Project	**IEEE 802.16 Broadband Wireless Access Working Group <**http://ieee802.org/16**>**
Title	**Proposed change on downlink control for multicast communication over IEEE 802.16n**
Date Submitted	**2012-03-06**
Source(s)	Eunkyung Kim, Sungkyung Kim, Sungcheol Chang, Won-Ik Kim, Seokki Kim, Miyoung Yun, Hyun Lee, Chulsik Yoon, Kwangjae Lim ETRI	Voice: +82-42-860-5415 E-mail: ekkim@etri.re.kr scchang@etri.re.kr
Re:	"IEEE 802.16-12-0142," in response to Letter Ballot #37 on P802.16n/D1
Abstract	Downlink control for multicast operation on GRIDMAN Draft Standard
Purpose	To discuss and adopt the proposed text in the draft amendment document on GRIDMAN
Notice	*This document does not represent the agreed views of the IEEE 802.16 Working Group or any of its subgroups*. It represents only the views of the participants listed in the "Source(s)" field above. It is offered as a basis for discussion. It is not binding on the contributor(s), who reserve(s) the right to add, amend or withdraw material contained herein.

Proposed change on downlink control for multicast communication over IEEE 802.16n

Figure 1—number of connections for multicast communication using HR Multicast DL Assignment A-MAP IE in 10MHz system bandwidth (mPA: no fragmentation, mDA: fragmentation)

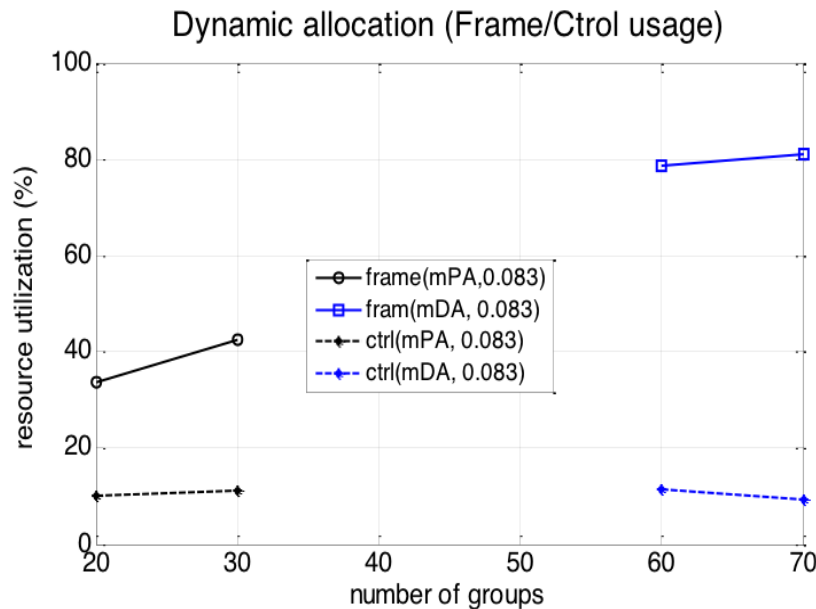
Figure 1 shows the number of connections for multicast communications using HR Multicast DL Assignment A-MAP IE. As shown the figure, number of connections using fragmented transmission is larger than that without fragmented transmission due to variable reason such as limit of resource in a subframe and level of MCS.

Thus, we propose a change on the downlink control for multicast communication (i.e., HR Multicast DL MAP IE).
